Taco Time

Preliminary Storm, SS, & Water Plan

Pre-1

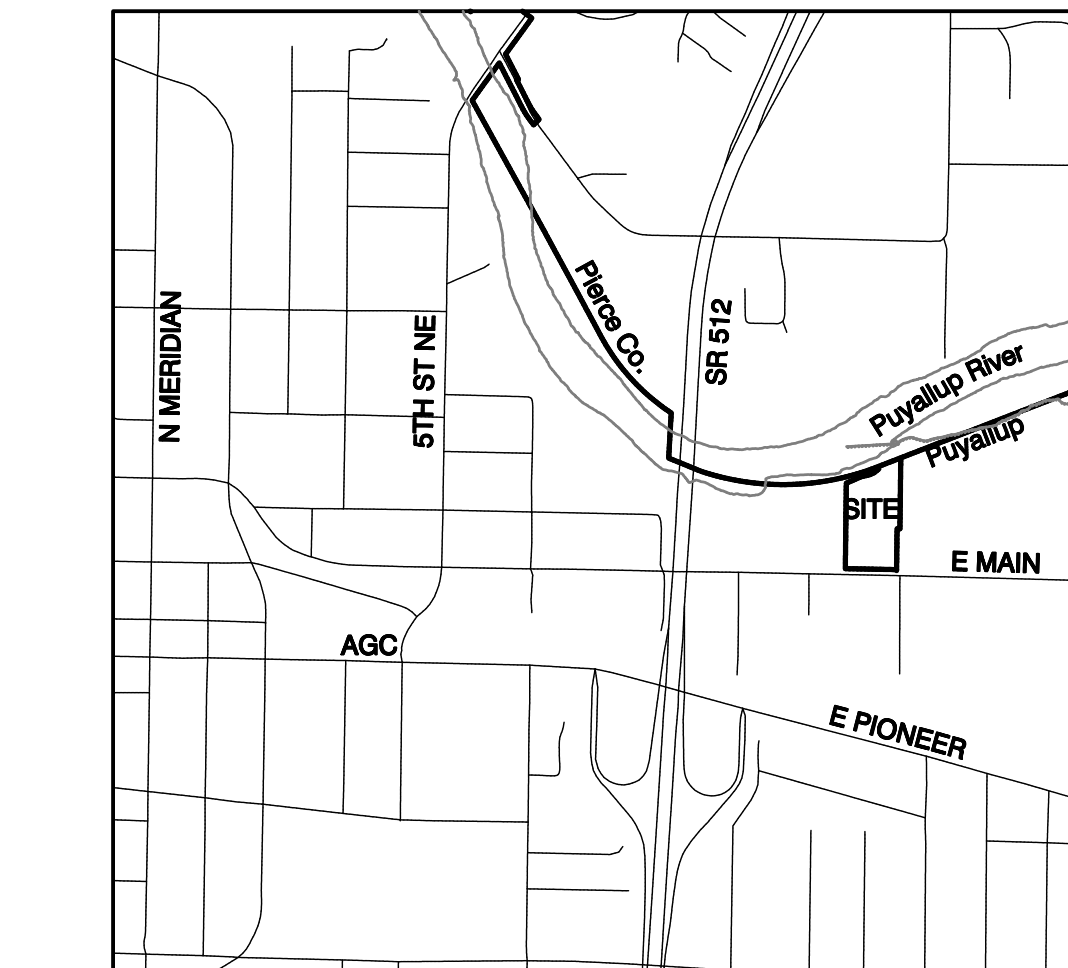
Give approximate cut/fill quantities. include excavation for storm system. [Preliminary Storm and Utilities rev1]

Show limits of disturbance and show all critical areas and steep slopes. No clearing, filling, grading or other alteration occurs within any critical areas or associated buffer unless specifically authorized pursuant to Chapter 21.06 Environmentally Critical Areas Management of the Puyallup Municipal Code [Preliminary Storm and Utilities rev1]

Be sure to review Latest City Standards updates. Design enclosure per City Standard Section 208.1. [Preliminary Storm and Utilities rev1]

Stormwater infiltration BMPs shall be set back 100-feet from retaining walls to prevent short circuiting of stormwater by free-draining rock behind the retaining walls, unless the bottom of the infiltration BMP is greater than 2-feet below the lowest point on the retaining wall. Confirm preliminary elevations of the wall and facility on plans. [Preliminary Storm and Utilities rev1]

Steep slopes are potentially in the vicinity of the proposed infiltration gallery. confirm slopes down stream of the facility location. All facilities shall be a minimum of 50 feet from any steep (greater than 15%) slope. [Preliminary Storm and Utilities rev1]

Infiltration systems must be a minimum 10' from other structures, including other infiltration systems. [Preliminary Storm and Utilities rev1]

Delineate between the existing limits and new/replaced limits of the asphalt/concrete pavements. Use a sawcut line and proposed asphalt shading. [Preliminary Storm and Utilities rev1]

All new/replaced hard surface and converted vegetation areas must meet the latest Ecology standards. If any new/replaced area goes to the existing system's basin, you must show the existing system is adequately sized using the latest standards. This calculation is possible but requires detailed basin and storage sizing clarifications. You must consider the amount of storage the non-disturbed existing hard surface area will be using in the existing infiltration gallery per the previously constructed standards. Then show the storage space left over has capacity for the new/replaced hard surface area in the basin. Add this narrative to Storm report. [Preliminary Storm and Utilities rev1]

Create a separate preliminary drainage basin map showing existing and new/replaced areas that go into existing storm system and any existing and new/replaced area going into the new storm system. [Preliminary Storm and Utilities rev1]

Provide a Table to reasonably estimate the quantity of existing and proposed hard surface areas. Include off-site areas. Use table attached to sheet as a guide for what is needed. [Preliminary Storm and Utilities rev1]
